# EPA Seeks Comments on Plan to Modify an Existing Carbon Storage Permit

Archer Daniels Midland Co.  
Decatur, Illinois

November 2016

EPA is proposing modifications to the Class VI permit for CCS#2 that address updated information about the site that ADM submitted pursuant to Title 40 of the Code of Federal Regulations (40 CFR) 146.82(c). These changes relate to the size of the area of review, final injection and monitoring well construction, and injection start-up procedures. All other changes to the permit and attachments are editorial or clarifying in nature. EPA is retaining conditions related to completed activities (e.g., related to well construction and pre-operational formation testing activities) in the permit.

*This map shows where the injection well is located.*

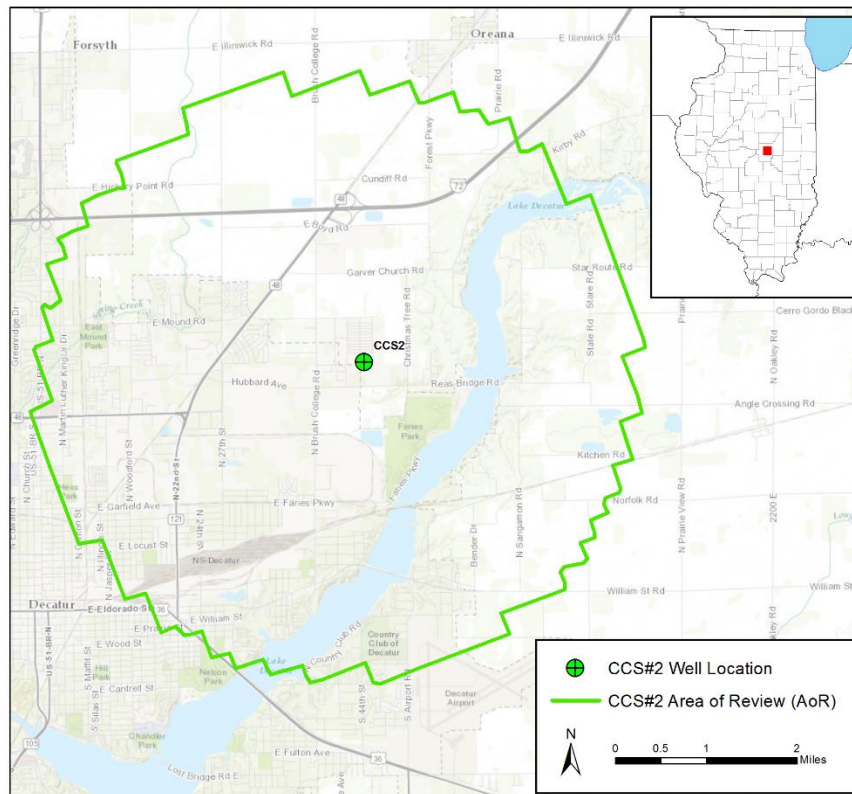
The U.S. Environmental Protection Agency plans to modify a permit for an injection well owned by the Archer Daniels Midland Company, 4666 Faries Parkway, Decatur, Illinois. The existing permit is for one injection well, CCS#2, that ADM wants to use to inject and store carbon dioxide, or CO<sub>2</sub>, underground. The CO<sub>2</sub> is created when ADM makes ethanol. ADM plans to inject 1.1 million metric tons of CO<sub>2</sub> per year into this well over five years.
